Status: Decision Rend	lered						
Appeal ID: 25061		Project Address: 1952 SE 122nd Ave					
Hearing Date: 8/11/21		Appellant Name: John Flynn					
Case No.: B-014		Appellant Phone: 5039395130					
Appeal Type: Building		Plans Examiner/Inspector: Preliminary					
Project Type: commerce	cial	Stories: 1 Occupancy: B, S-1 Construction Type: V-B					
Building/Business Na	me: Mill Park Center	Fire Sprinklers: No					
Appeal Involves: Altera Change from S-1 to B	ation of an existing structure,oo	LUR or Permit Application No.:					
Plan Submitted Option	n: pdf [File 1] [File 2]	Proposed use: Office					
APPEAL INFORMA  Appeal item 1  Code Section	OSSC 1006 Number of Exits	and Exit Access Doorways					
Requires	1006.2.1 Egress based on occupant load and common path of egress travel distance. Two exits or exit access doorways from any space shall be provided where the design occupant load or the common path of egress travel distance exceeds the values listed in Table 1006.2.1.

# Increase in the common path of egress travel from 75 feet to 83 feet: Granted as proposed for this tenant and configuration.

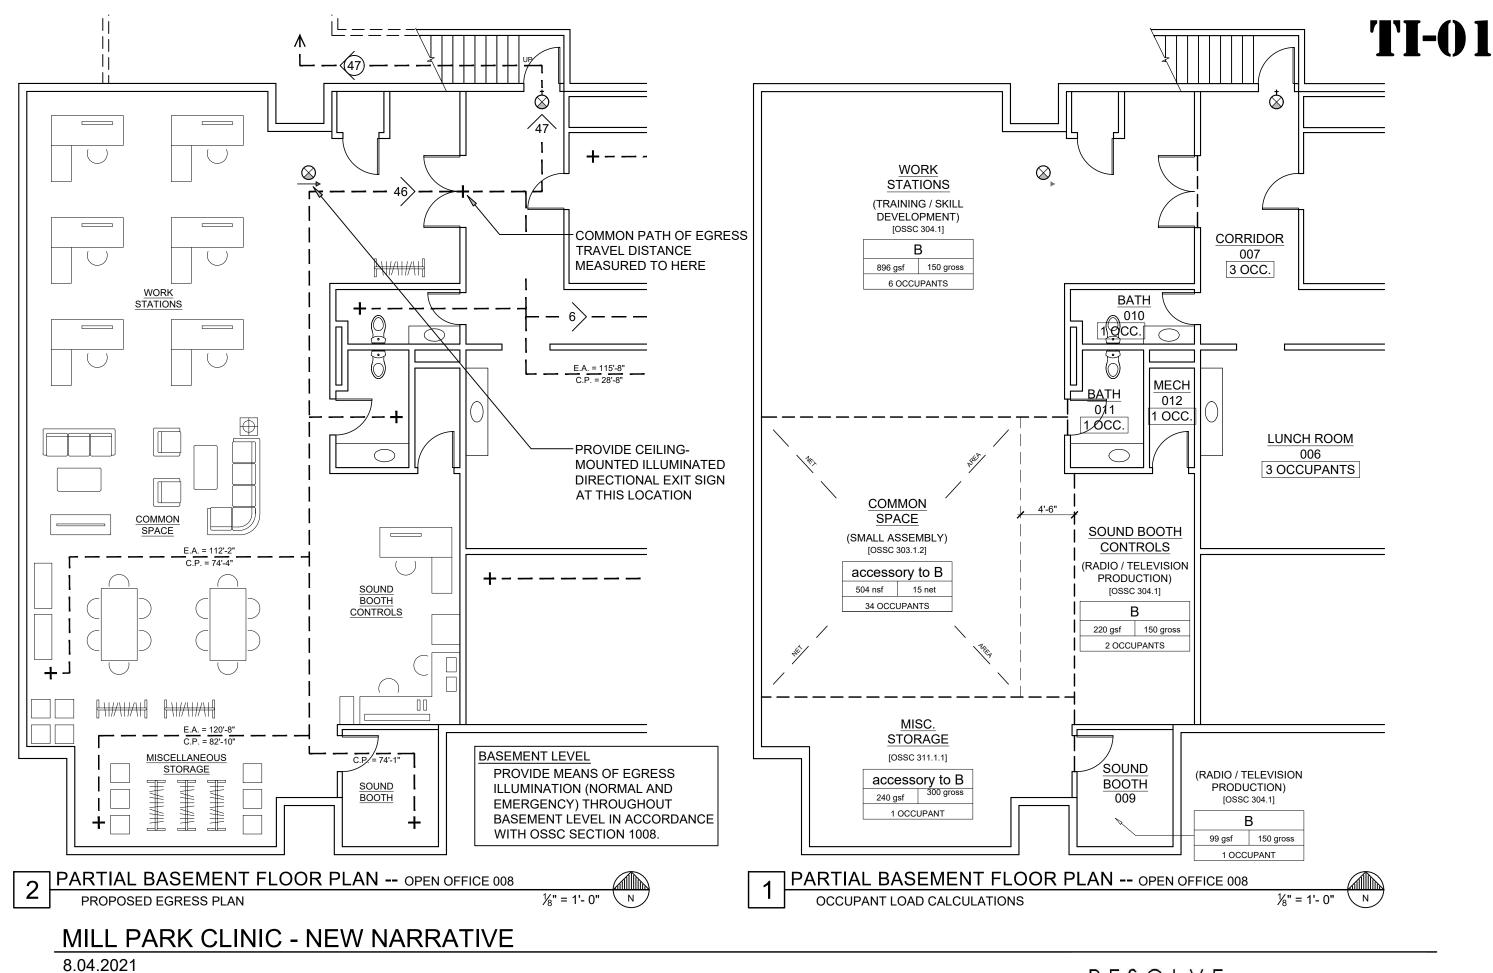
Code Modification or Alternate Requested	Table 1006.2.1 identifies the limiting criteria for spaces with one exit or exit access doorway. For the proposed occupancy, occupant load, and no sprinklers, the maximum common path of egress travel distance is 75 feet. The proposed design shows one exit from the space under consideration and a common path of egress travel distance of 82'-10". The Appeal request is to allow the common path of egress travel distance of 82'-10" under the specific conditions presented.						
Proposed Design	This is a one-story building with a full basement. The current occupancies are Group B (offices, at the ground floor level and for a portion of the basement level) and Group S-1 (storage, at the remaining 2,053 gross square feet of the basement level.) The basement level has two exits. The proposed design shows a change of use at the basement level, reconfiguring the storage area into open office. Sheets 1 and 2 (attached) provide occupant load calculations and egress analyses for both floors of the building.

Space planning and occupant furniture layouts for the new Open Office area have been prepared to identify accessory uses to the proposed B occupancy. In addition to general training and audio production space, the Open Office is also programmed for small assembly space (per OSSC 3003.1.2) and storage space. Please refer to enlarged plans 1 and 2 on attached sheet TI-01.						
	3003.1.2) and storage space	Please refer to enlarged plans 1 and 2 on attached sheet 11-01.

occupant.) All other areas within the Open Office have common path travel distances that are less than 75 feet.

In addition to code required exit signage, the proposed design includes a ceiling-mounted, illuminated, directional exit sign within the Open Office space which will provide increased visibility of the egress route from the room. See plan 2, sheet TI-01.

Reason for alternative The layout of rooms at the basement level is an existing condition and it is not practical to add a second exit from the new Open Office space. As well, the common path of egress travel distance only exceeds the required maximum by approximately 10%. The tenant plan places a low-occupancy accessory use (storage) at the area where the common path travel distance is greater than the maximum 75 feet. Finally, the added exit signage will make the path of exit travel simple and easy to navigate.

The Administrative Appeal Board finds that the information submitted by the appellant demonstrates that the approved modifications or alternate methods are consistent with the intent of the code; do not lessen health, safety, accessibility, life, fire safety or structural requirements; and that special conditions unique to this project make strict application of those code sections impractical.
